Pre-Bid Request for Information
SHAW AFB - DFAC & Flight Kitchen Construciton
RFP # F41999-25-R-0009

19-Aug-25

Pre-Bid Request for Information
SHAW AFB - FLIGHT KITCHEN RENOVATIONS
RFP # F41999-25-R-0009

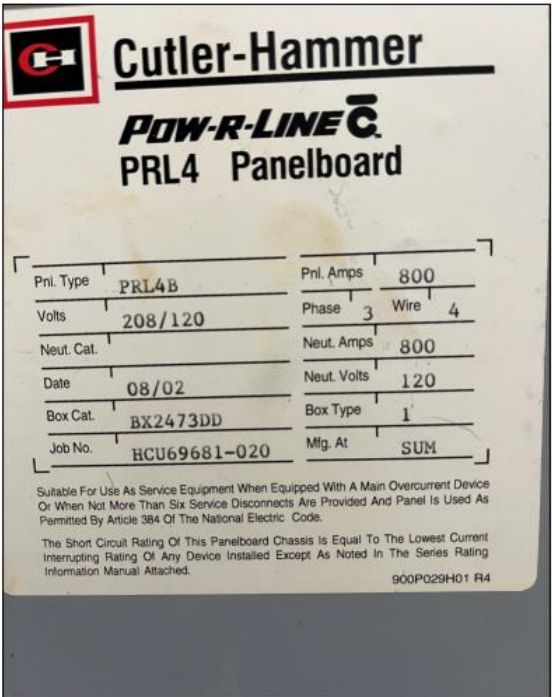
RFI #	Action Office	Question	Answer	Status
1	DOR	Please provide manufacturer of the existing switch gear (MDP) and (SWB1), including serial and/or catalog number.	ED - 08/13/2025 - Please see tabs 'MSB1 Pictures' and 'MDP Pictures' showing the manufacturer, catalog # and Job #.	CLOSED
2	DOR	Please confirm there is space for new added breakers (9,12,13,14,15,16, and 17).	ED - 08/13/2025 - With the removal of the 400A 'AC' circuit breaker and the space below it, there will be enough space to mount the new twin-mount circuit breakers. If the panel is not fully bussed, provide an alternate bid for: Use the existing 400A circuit breaker to feed a new 400A, 208Y/120V, 3ph, 4w panel. The new panel will be mounted to the south wall of the electrical room. The new panel will feed the new loads (load centers A-E and dish machines).	CLOSED
3	DOR	The door schedule on Sheet A701 calls for Hollow Metal (HM) doors and frames, but the specifications provided are for Section 08 14 00 – Wood Doors. Please confirm whether HM doors per Section 08 11 13 are required, and if so, provide the applicable spec section.	RAM - 08/13/25 - Specification Section 08 11 13 Steel Doors and Frames is provided in response to this RFI.	CLOSED
